MEMORANDUM

To: The Design Advisory Board
From: Mary O'Neil, AICP, Principal Planner
RE: ZP18-0481SP; 298 College Street
Date: **Wednesday**, December 13, 2017

File: ZP18-0481SP
Location: 298 College Street (former Ethan Allen Club)
Zone: RH **Ward:** 8E
Parking District: Neighborhood
Date application accepted: November 13, 2017
Additional material submitted: November 30 and December 1, 2017
Applicant/ Owner: Freeman French Freeman, Inc. / Kyle Dodson for Greater Burlington YMCA
Original Technical Review: February 11, 2016
Next Technical Review: December 14, 2017
Request: Redevelopment of the former Ethan Allen Club for the Greater Burlington YMCA; Basement plus two stories, approximately 65,000 sf (22,000 sf footprint.) Request for parking waiver.

Overview: This is Sketch Plan Review for the proposed redevelopment of the former Ethan Allen (membership) Club to the Greater Burlington YMCA. The existing building is proposed to be demolished, a replacement structure of approximately 65,000 sf with 39 parking spaces on-site, 12 off-site planned. A 73% parking waiver is requested.

Existing perspective from Bradley Street. Google image 2017.

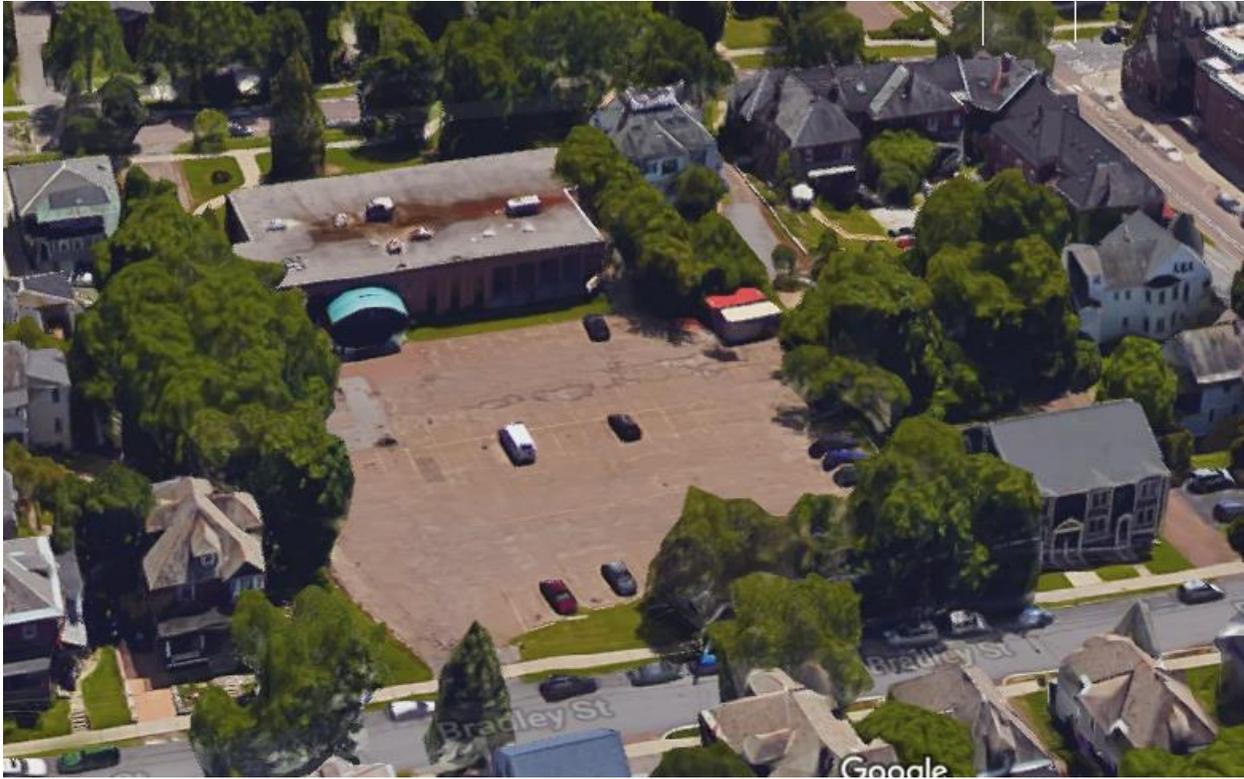
Unfortunately, the north street building frontage does not demonstrate alignment with neighboring buildings to reinforce the street edge but tends to duplicate the existing expanse of parking, albeit with two accessory structures and a fence-atop-retaining wall. The proposal plans to extend the siding (which matches the main building beyond) as a skirt down to grade below the interior finish floor.

The retaining wall with wooden guardrail proposed for the north street front of the lot has a preliminary estimate of 99' linear feet along Bradley Street with a height up to 8'. With no principle structure to fill in the street wall, the plan threatens to deaden the pedestrian experience with parking and sheds along the streetfront. The accessory uses (parking, storage) have secured a position in a place of prominence and visibility, treating it as a back yard rather than a street frontage. Plainly, the plan turns its back on Bradley Street, contrary to this standard.

Accessory structures should be placed in a less visible location; deferential to the principal structure or use. Alternately, the plan may move toward a Planned Unit Development where more than one principal building occupy the site (RH has no minimum project size). A second building, fronting Bradley Street would satisfy strengthening both street walls with new development, which may include these accessory uses.
